Release Note for Yeastar N824

FIRMWARE VERSION 42.14.0.23

July 14, 2016

CHANGES SINCE FIRMWARE RELEASE 42.13.0.27

2. Added support for dialing external numbers when in an IVR.

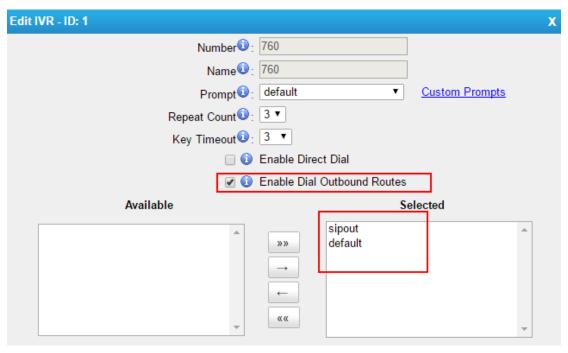
Instruction: check the option "Enable Dial Outbound Routes" and choose the outbound route. When the caller enters the IVR, he/she can make an outbound call through the PBX.

3. Added support for customization of ring tones.

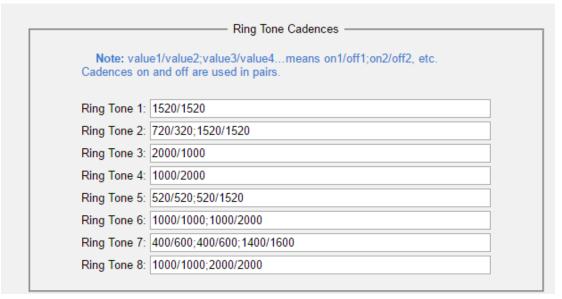
Instruction: Customize the ring tone cadences then click "Save" and "Apply".

12. Added option "Off-Hook Dial Delay" to set the delay on CO line between off-hook and dialing digits.

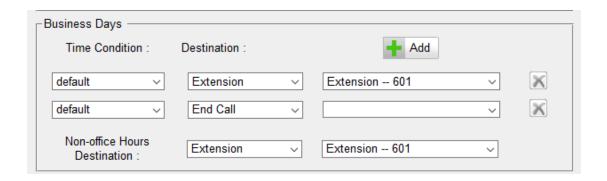
Instruction: this sets the delay on CO line between off-hook and dialing digits. The allowed range is from 0 ms to 5000 ms. Setting it to "0" means no delay. The default is "0".

15. Added option "DNS-NAPTR" to search SIP trunk transport, port and server.

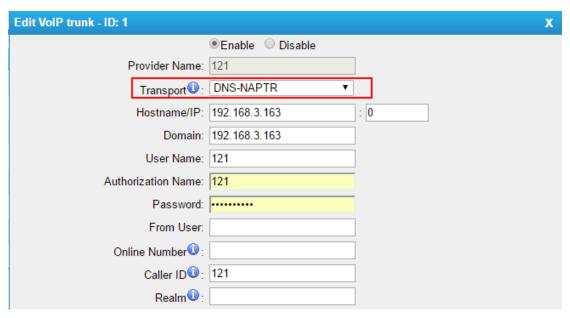
- If "Hostname/IP Address" is the PBX's Hostname and the port is 0 or blank,
 NAPTR and SRV lookup will be executed to search for transport, port and server.
- If "Hostname/IP Address" is a valid IP address or a designated port then UDP will be used.
